Model: GR-C1 ARDF		Date: 16-Apr-15	No.: RD606001
Subject: Defective ARDF cover around the right hinge		Prepared by: T.Kiyohara	
From: 1st Tech Service Sect., MFP/P Tech Service Dept.			
Classification:	<input type="checkbox"/> Troubleshooting <input checked="" type="checkbox"/> Mechanical <input type="checkbox"/> Paper path <input type="checkbox"/> Product Safety	<input checked="" type="checkbox"/> Part information <input type="checkbox"/> Electrical <input type="checkbox"/> Transmit/receive <input type="checkbox"/> Other ()	<input type="checkbox"/> Action required <input type="checkbox"/> Service manual revision <input type="checkbox"/> Retrofit information <input type="checkbox"/> Tier 2

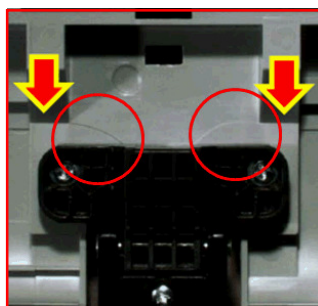
The ARDF cover is damaged around the right hinge, as shown in the photo.

Constant opening and closing of the ARDF produces concentrated stress in the areas circled in yellow in the photo. As a result, fatigue in these areas causes cracks to form and eventual breakage.

The shape of the ARDF hinge holder was changed to increase resistance to these stresses.

If the cover breaks, replace the entire ARDF unit.
